MILITARY SPECIFICATION

SYNCHROS, 60 CYCLE, 115 VOLT

This amendment forms a part of MIL-S-2335, dated 8 August 1950, and is mandatory for use by all Departments and Agencies of the Department of Defense.

MIL-S-2335
 AMENDMENT 1

FIGURE 9. NOISE TEST FIXTURE

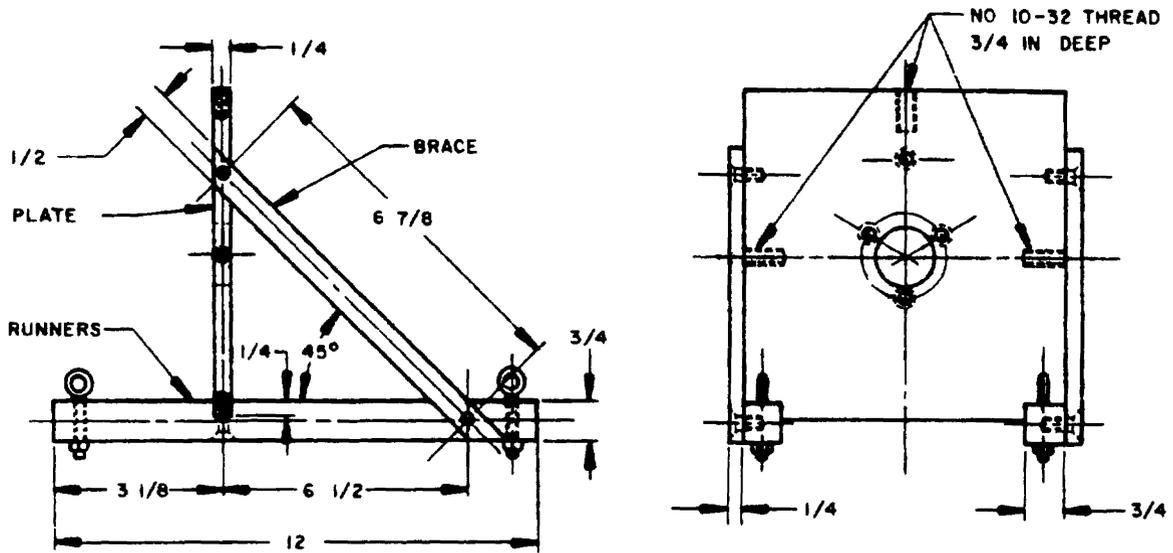
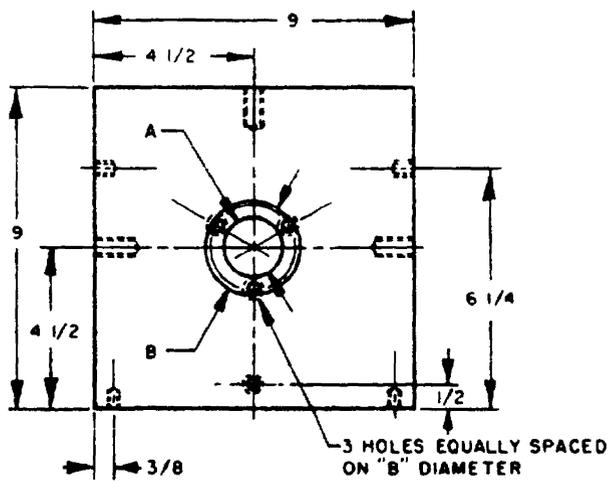
Replace page 58 (Figure 9 "Block Diagram of Synchro Noise Test") with new page 58. (Figure 9 "Noise Test Fixture") See page 3 of this amendment.

for conducting the structureborne noise test. The alternate mounting instructions described herein shall be used only when specified by the procuring activity. The synchro shall be mounted on the noise test fixture described by Figures 9 and 10 utilizing standard mounting hardware. The synchro shall be oriented on the test fixture with the synchro zero mark in the vertically up position. The unit and fixture combination shall be suspended as shown in Figure 10 in such a manner that the axis and the top edge of the mounting plate are horizontal within five degrees"

FIGURE 10. TEST FIXTURE APPLICATION FOR STRUCTUREBORNE NOISE TESTING

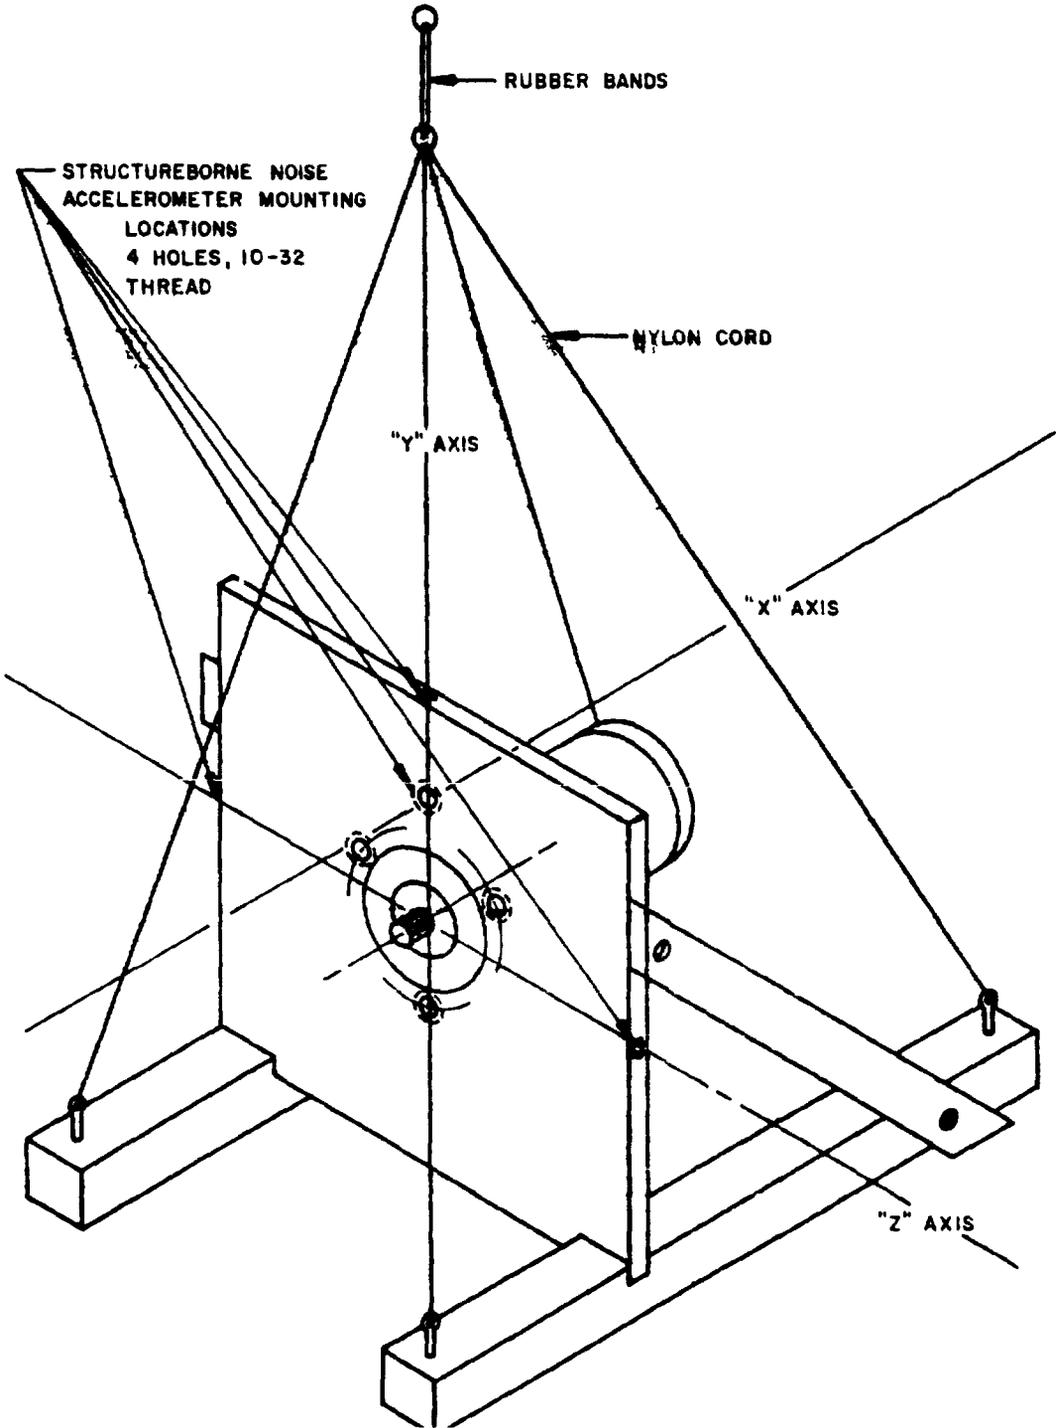
Following page 58 (Figure 9) add new page (Figure 10 "Test Fixture Application for Structureborne Noise Testing") See page 4 of this amendment.
